ZONE CHANGE REVIEW SHEET

CASE: C814-88-0001.10
Canyons @ Rob Roy Rezoning

ADDRESS: 800 N. Capitol of Texas Highway

Staff recommends Planned Unit Development (PUD) zoning with the following changes to Exhibit “H” of the PUD Land Use Plan -

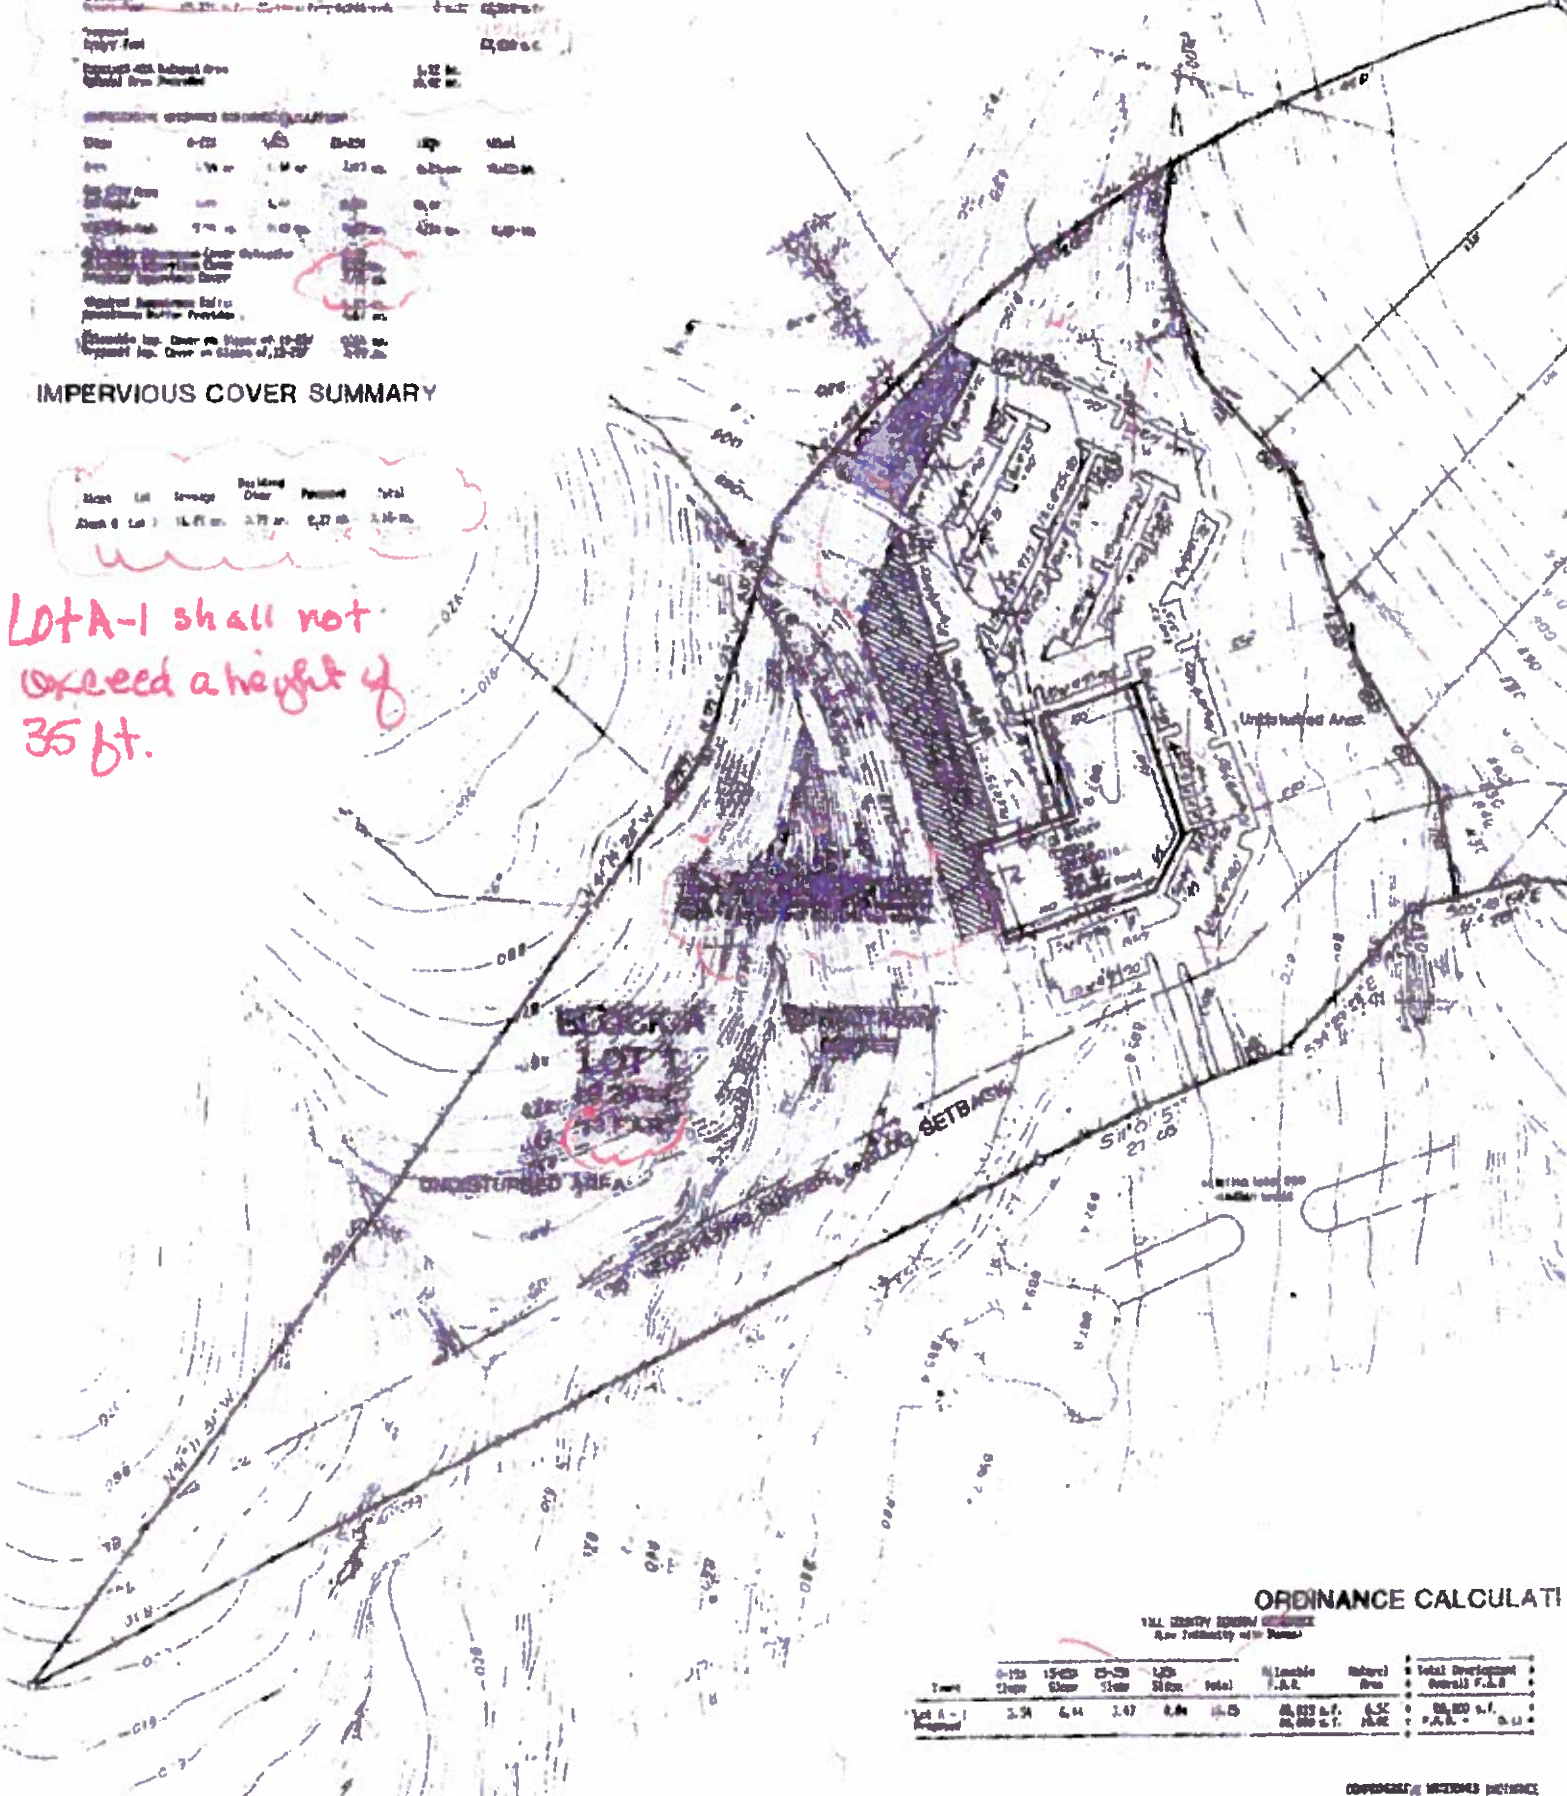
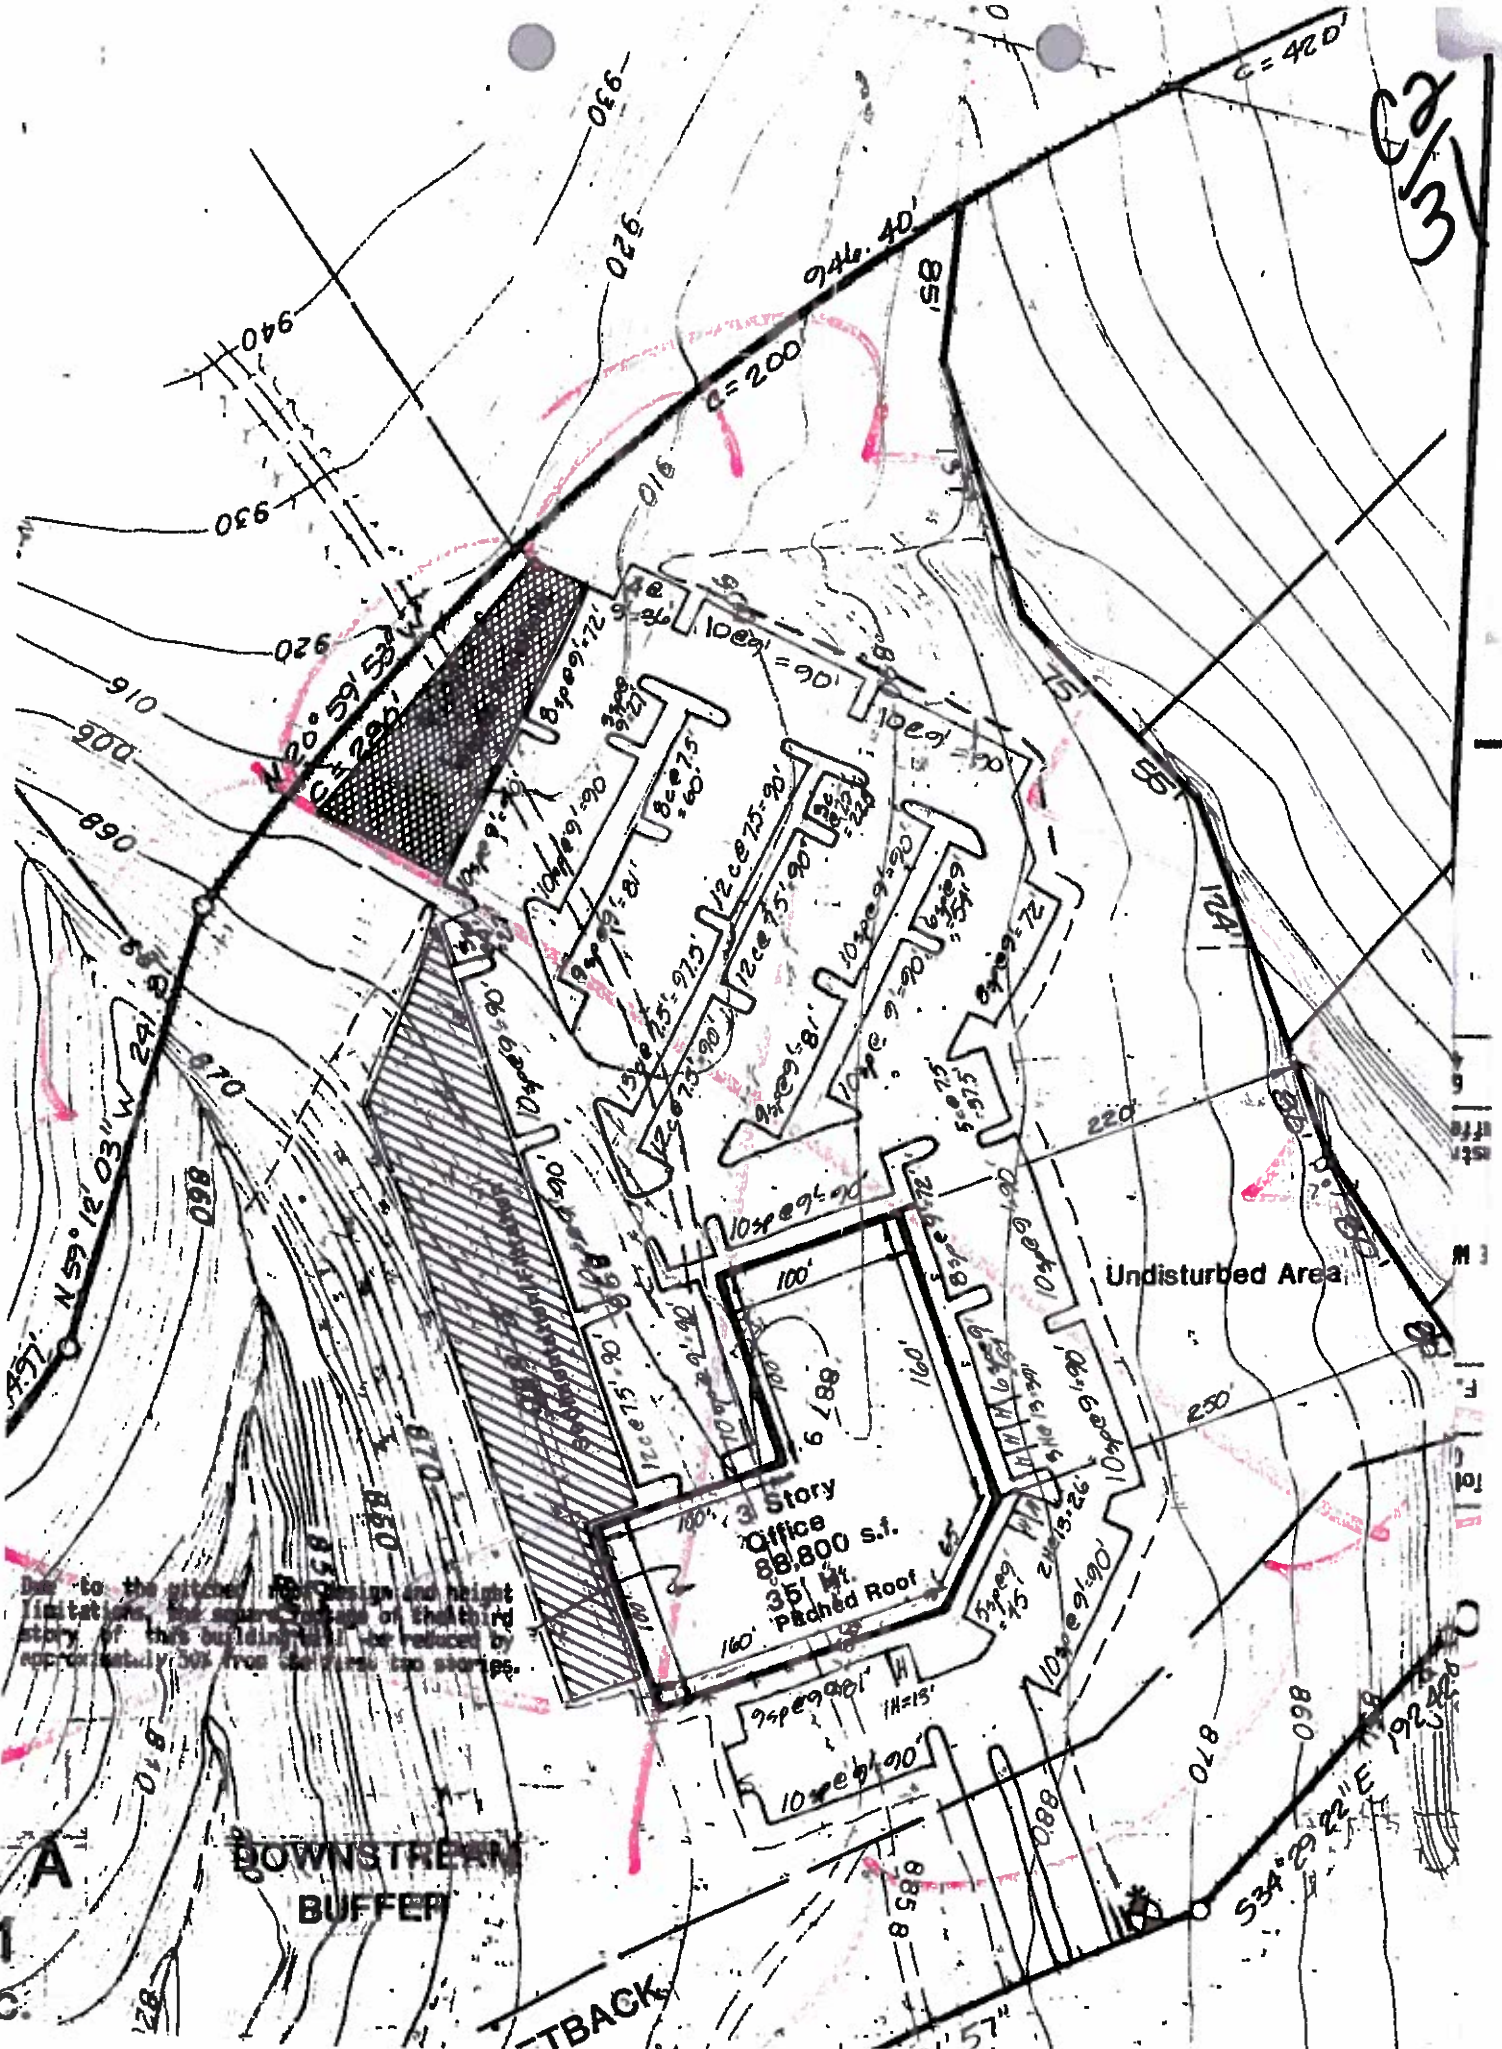
Exhibit "H" Land Use Plan. Remove the diagram on Sheet 3 of the office project.

Exhibit "H" Land Use Plan. Add a note on Sheet 3 that clarifies the maximum height allowed on Lot A-1 is 35 feet.

Exhibit "H" Land Use Plan. Remove the note on Sheet 3 that reads "Due to the pitch of the roof design and height limitations the square footage of the third story of this building will be reduced by approximately 50% from the first two stories.

Justification. Zoning is used to establish the best use for a site and should not be used to dictate the location of site improvements. This should be deferred to the site development stage when engineered documents and related reports are available to assess the proper location of improvements based on site constraints. Also by removing the diagram from the land use plan it prevents future amendments to the PUD should the location of the site improvements fluctuate slightly.

Justification. There is no change from the previous proposal.

Justification. This note is unnecessary since the building is limited to 35 feet with height limit exceptions, as prescribed by 25-2-531 of the City Code, for certain architectural elements including pitched roof designs.
